REMEDIATION SYSTEM REVIEW REPORT  
WALLY'S OIL  
ROUTE 7, BOX 89  
WILTON, MINNESOTA  
MPCA SITE ID #: LEAK000089

Terracon Project No. 41057007  
February 24, 2006

RE: Remediation System Review Report  
Wally's Oil  
Route 7, Box 89  
Wilton, Minnesota  
MPCA Site ID #: LEAK000089  
Terracon Project No. 41057007

**FIGURE 7**  
ESTIMATED RECOVERY WELL CAPTURE ZONE  
(THEIR SOLUTION)  
WALLY'S OIL COMPANY  
WILTON, MINNESOTA

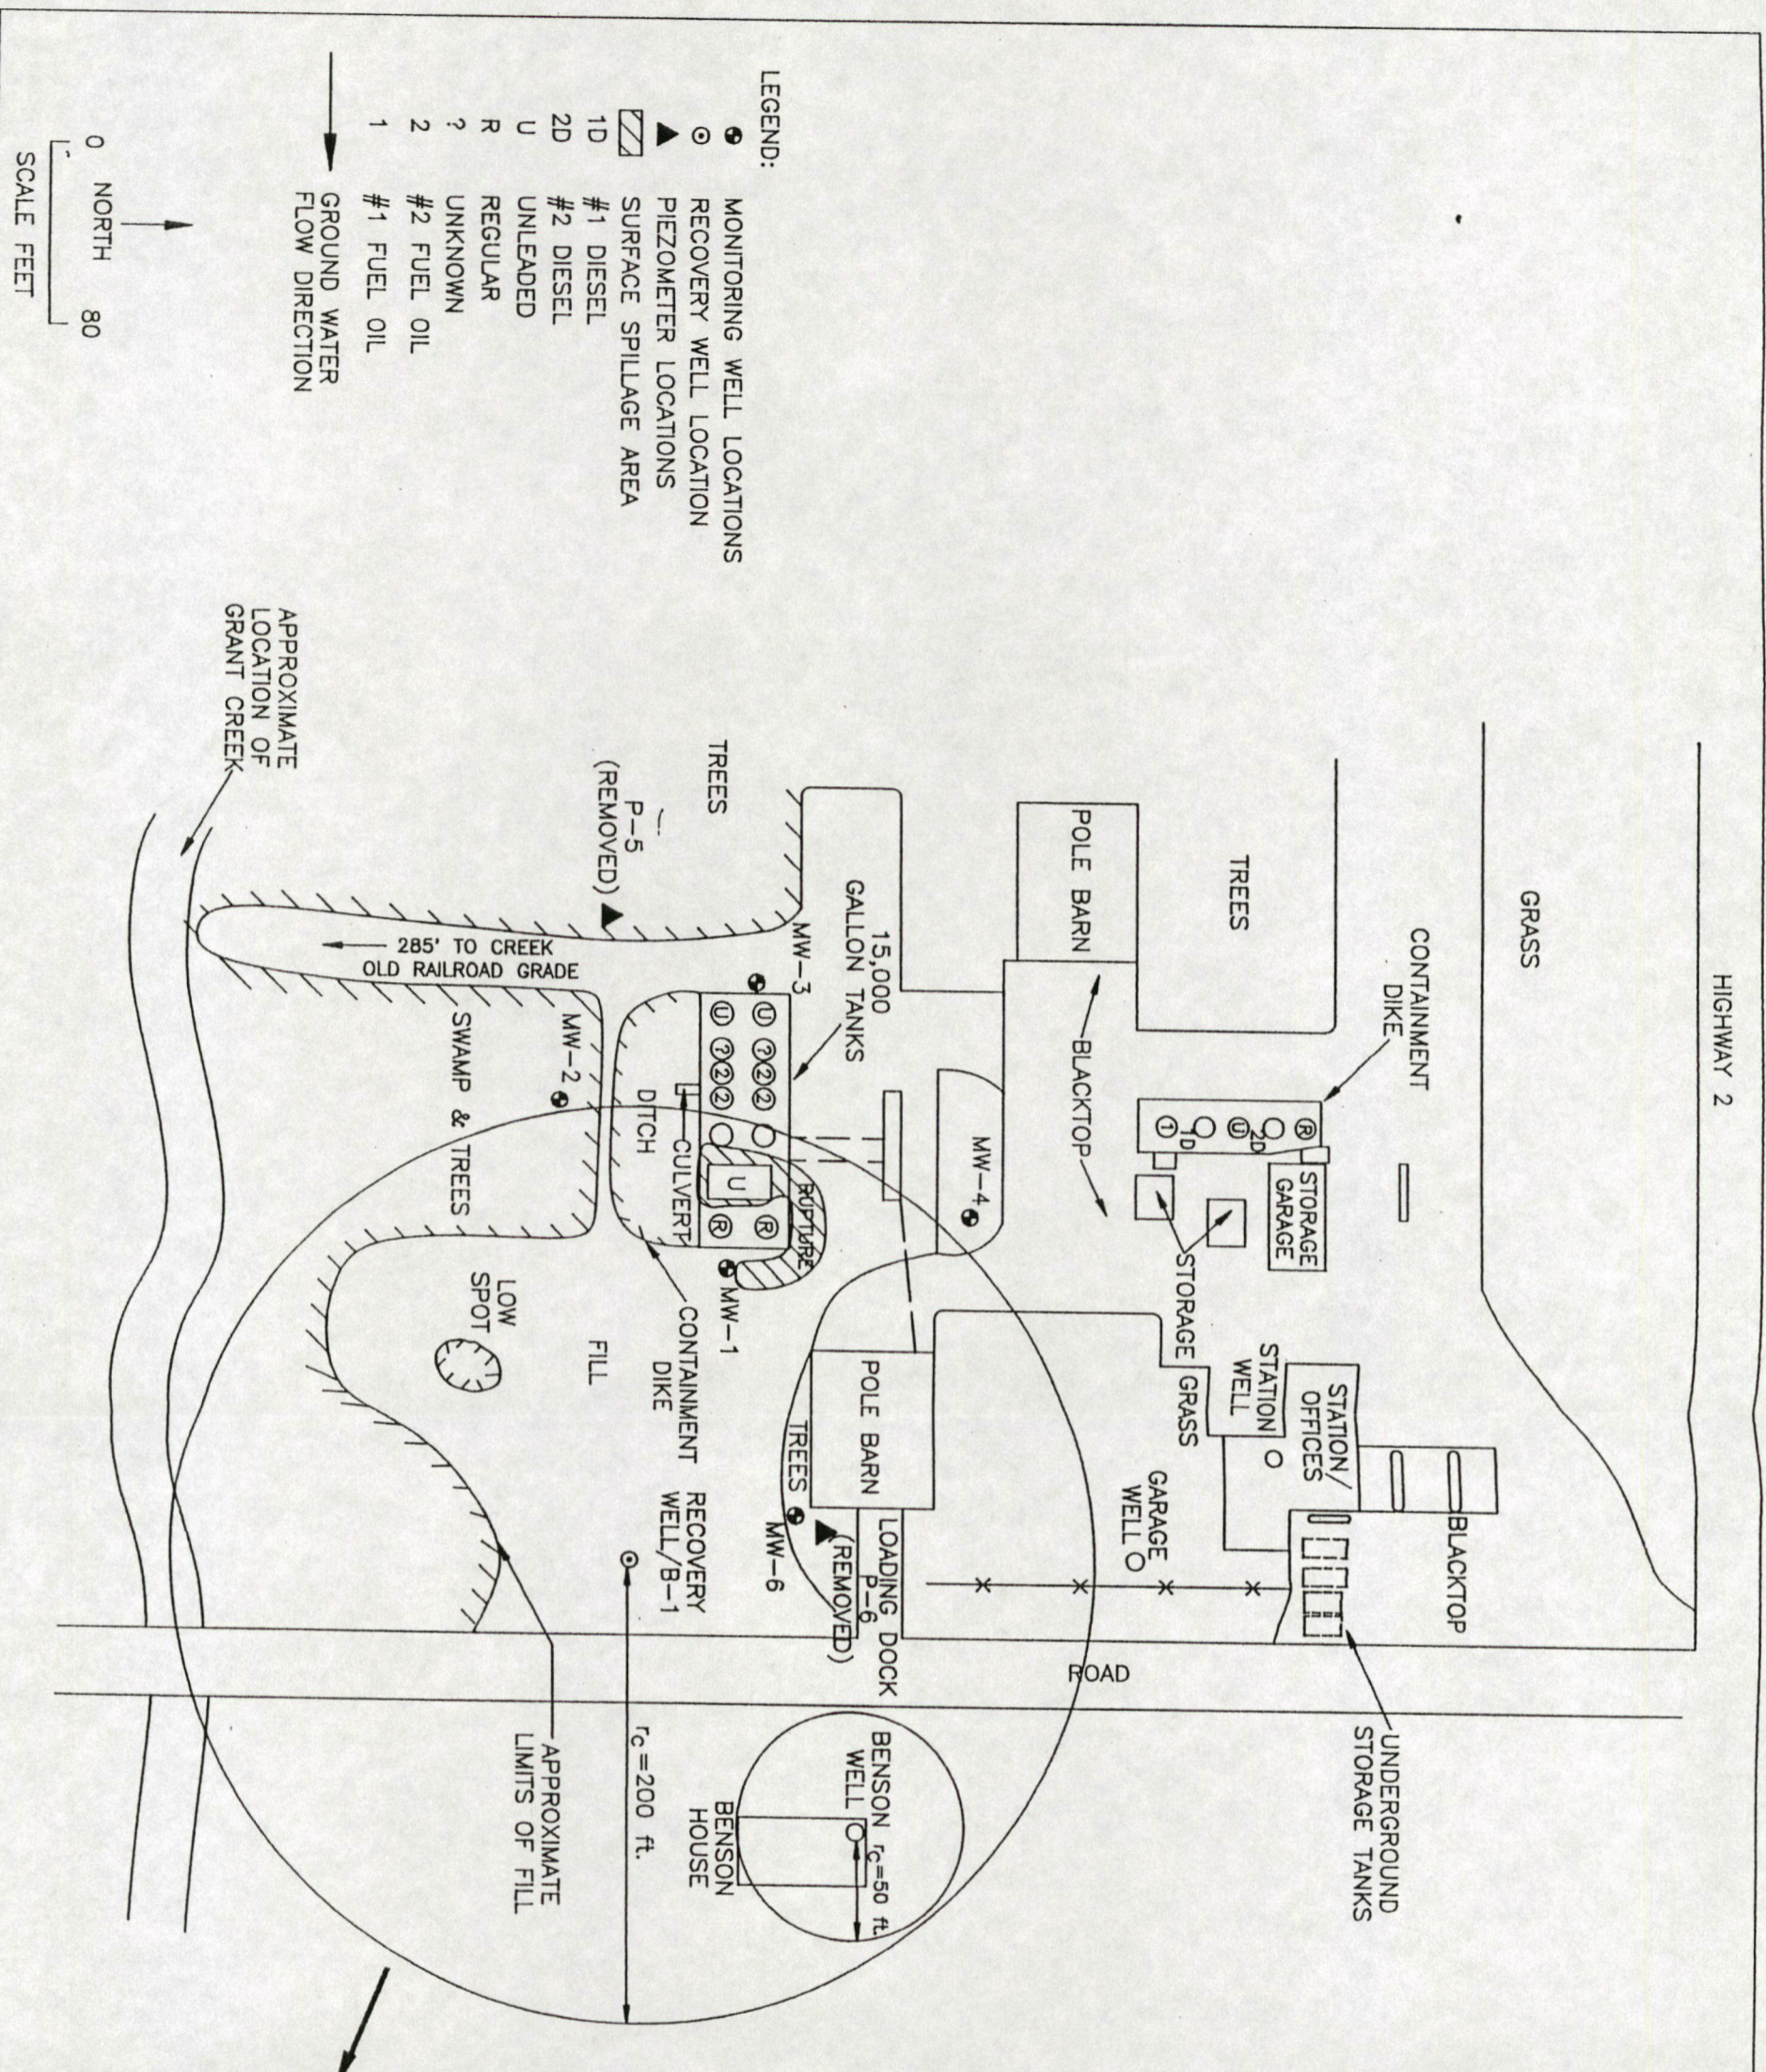
The recovery well was used to conduct a pumping test that was used for evaluating the feasibility/effectiveness of using a recovery well. The results of the environmental assessment activities appear to have been used to design the pump & treat system. The specific parameters used, such as the groundwater contaminant concentrations, for designing the treatment units (i.e., OWS and DAT) were not identified or reported. The groundwater pumping test data does not appear to be adequate to support the inferred radius of influence of the recovery well.

**FIGURE 9**  
 WALLY'S OIL CAD REVIEW  
 Terracon Project No. 41057007

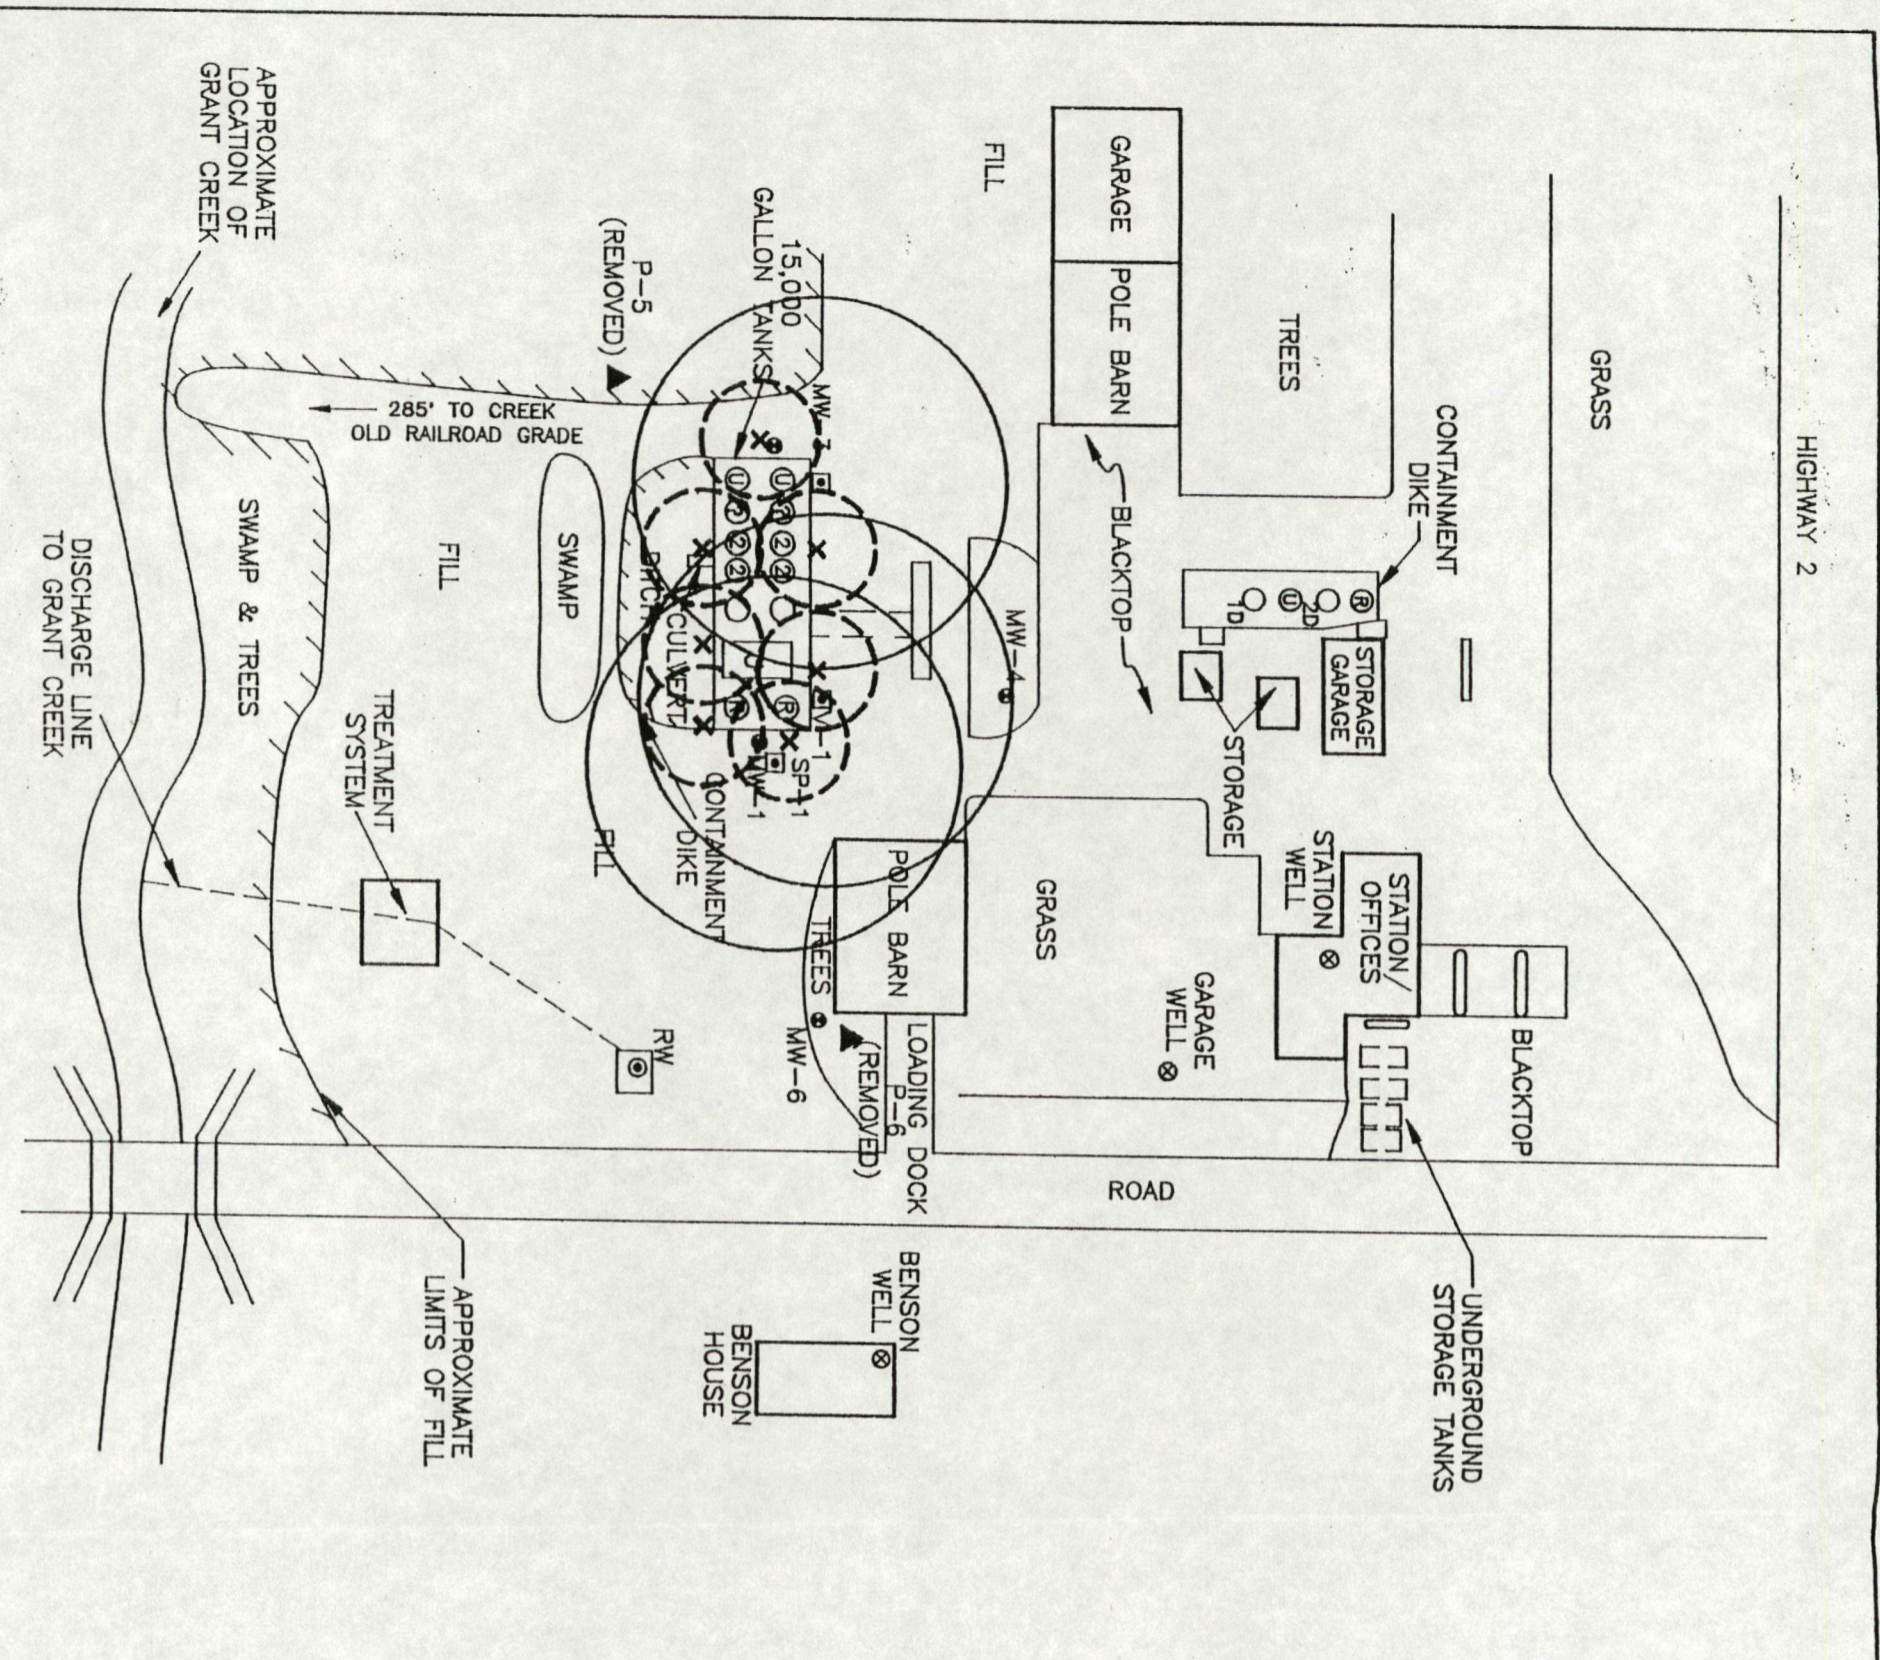
- A radius of influence of 20 to 25 feet was reported for flow rates between 10 and 20 cfm at pressures of 5 pounds per square inch (psi), which is equal to 139 inches of water.
- Seven sparge points were recommended. The AS system would cycle each point at 20 cfm and 10 psi (277 inches of water). The rationale for specifying the air flow rate/pressure was not discussed and did not include the length of the cycling periods.
- A map showing the proposed vent and sparge point locations along with the respective radius of influence areas depicted was included in the CAD (Figure 9). Three vent points are shown on the map which is not consistent with the four proposed.
- A piping and instrumentation diagram showing the proposed AS/SVE system was also included in the CAD (Figure 10).

Direct measurements and observations conducted during the AS/SVE pilot test support the specified radius of pressure/vacuum influence. Although it is Terracon's opinion that the methods and procedures used to collect the data should have been more thoroughly described. In addition, the vapor extraction air flow rate was operated at a constant flow rate and pressure, which is insufficient for evaluating possible alternatives to the size of blower and the number of vent points. Furthermore, the screen size (i.e., 10-slot and 10 feet in length) used and the depths at which the screen was set (i.e., 3 to 13 feet bgs) for the vent point may have provided poor air vacuum/air flow performance data due to the proximity to groundwater and the ground surface. Upwelling is more common when 10-slot screens are used. A greater influence from short-circuiting and/or preferential air flow occurs when the top of vent screens are located close (i.e., within five feet) to the ground surface. Moreover, a radius of influence of 80 feet for a vapor extraction vent screened at 3 to 13 feet is suspect, unless an impervious surface cover (i.e., pavement) was present.

### FIGURE 10

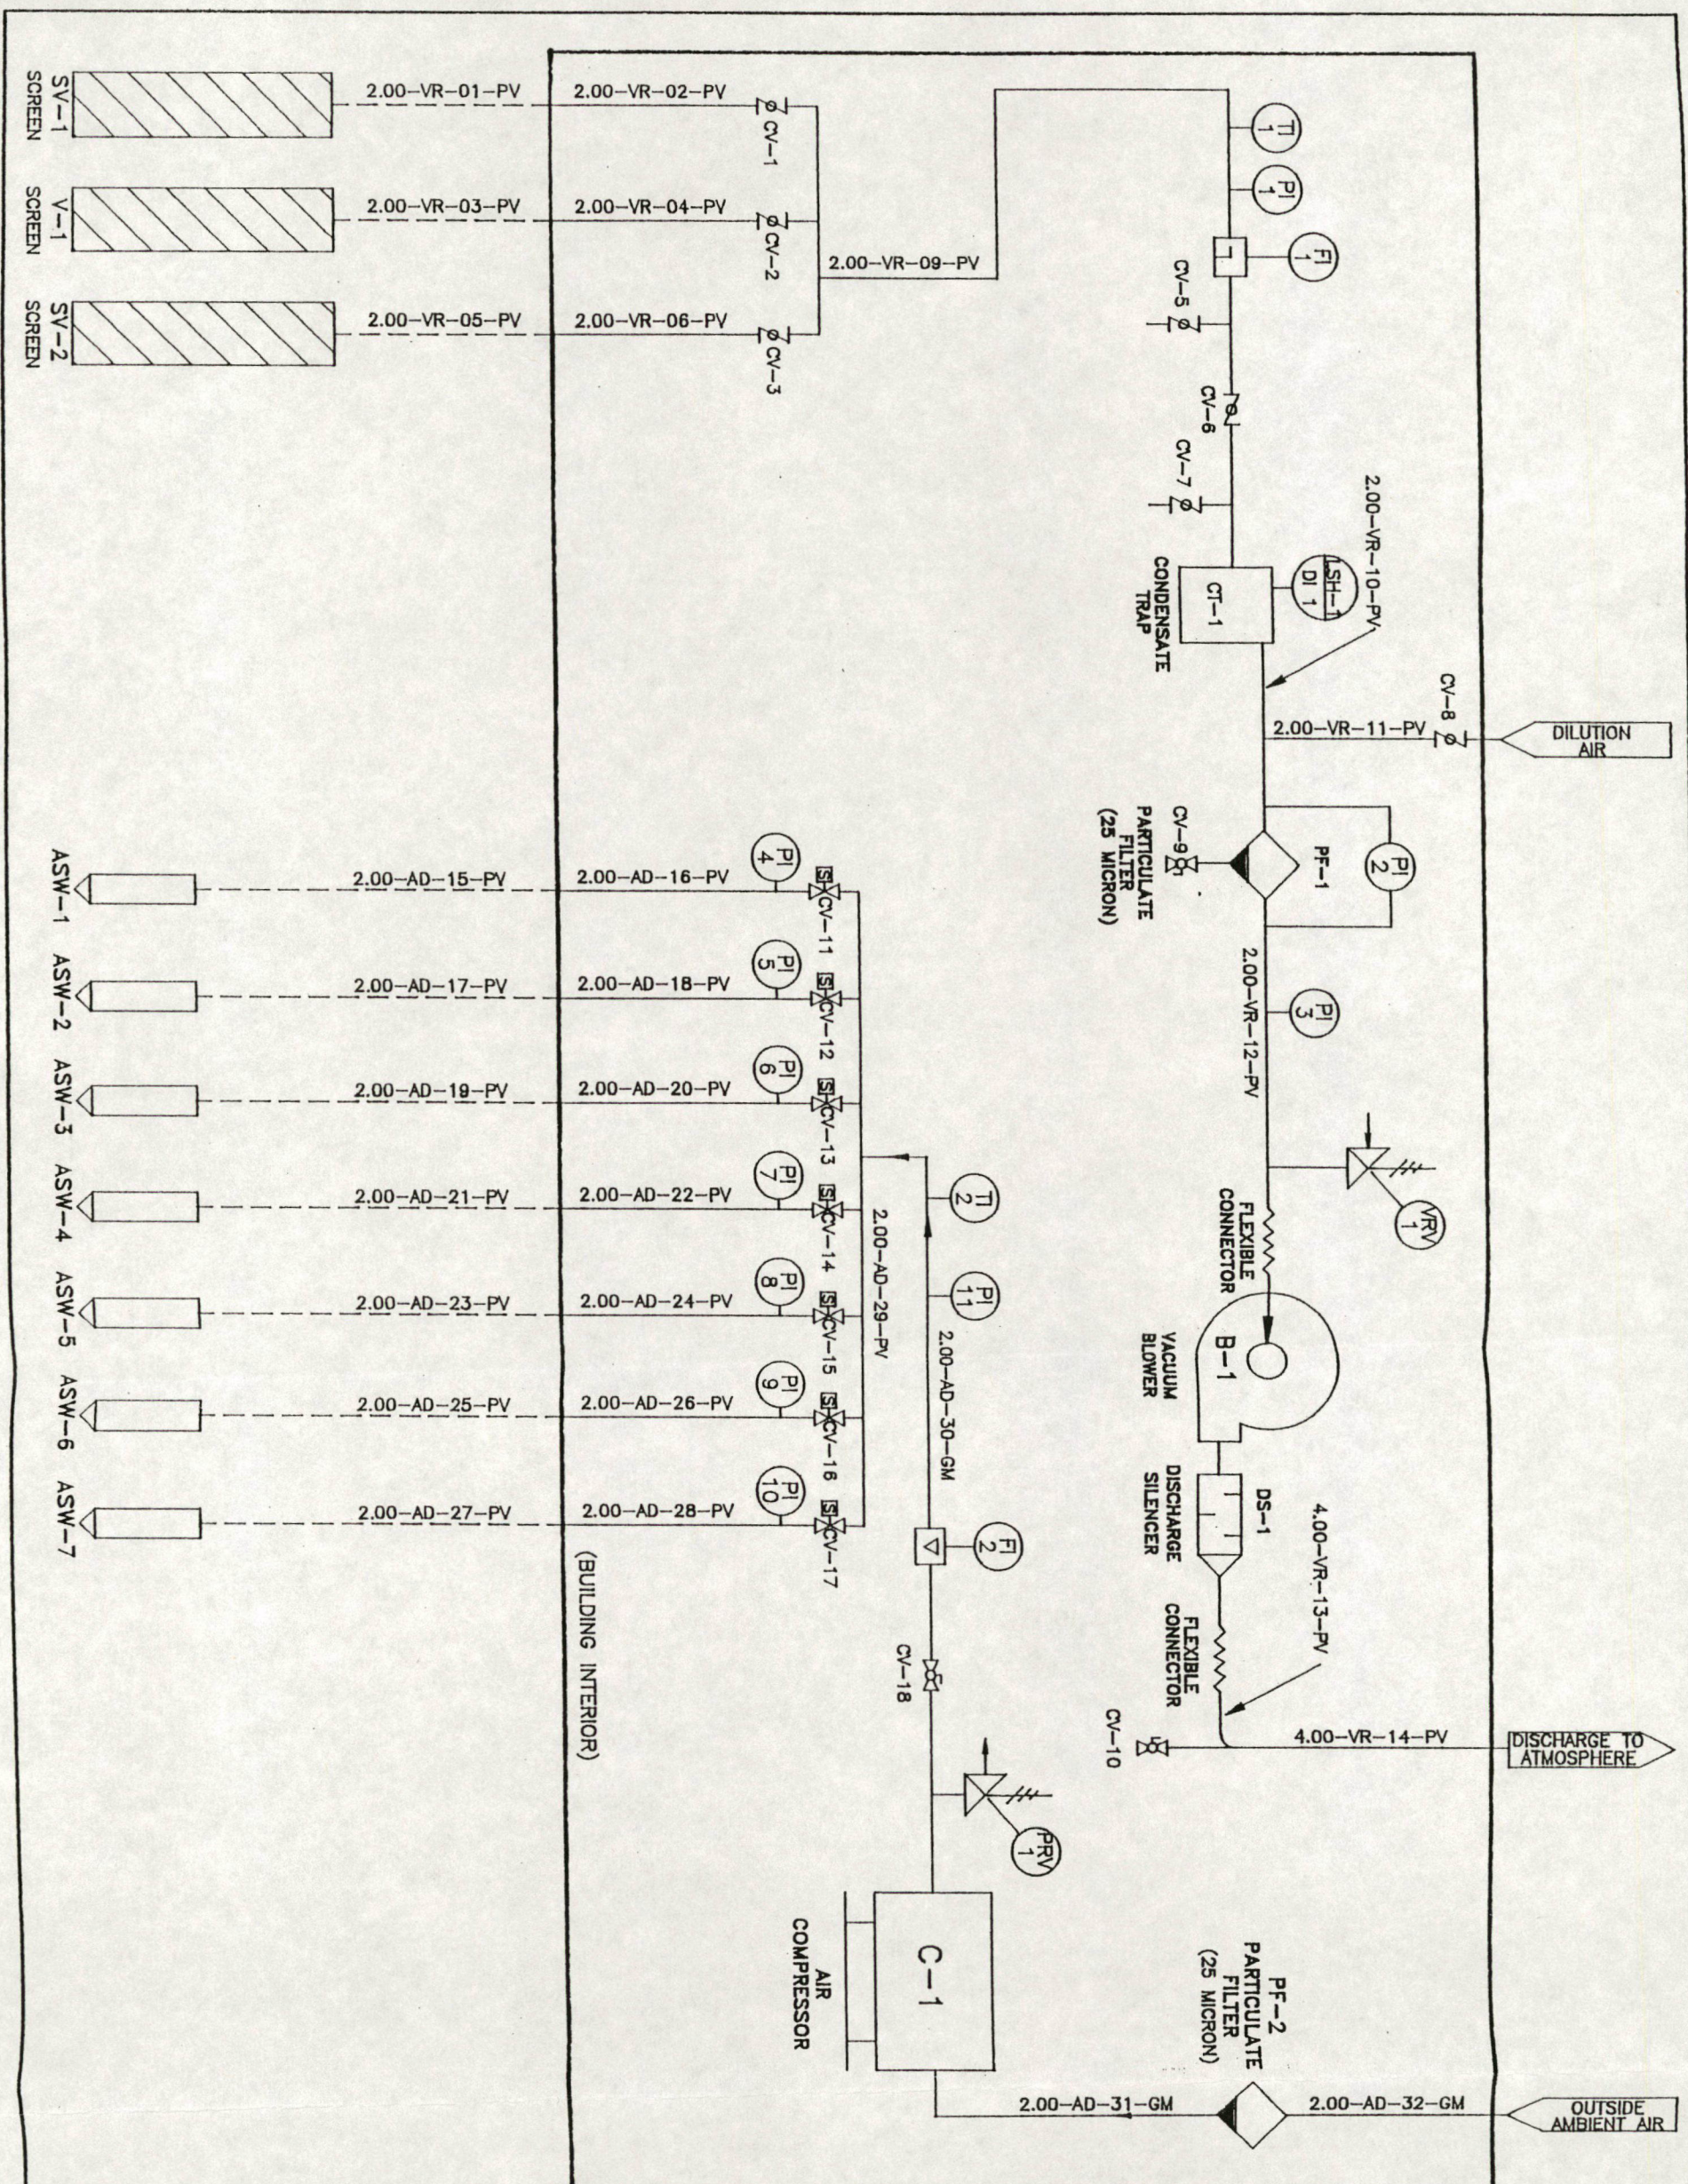
- Based on the Process Flow Diagram, three vent points and seven sparge points were installed. The information was deficient and did not include the configuration of each vent point or sparge point such as the depth of screen, type of construction materials, etc, or a figure showing the locations of the points.
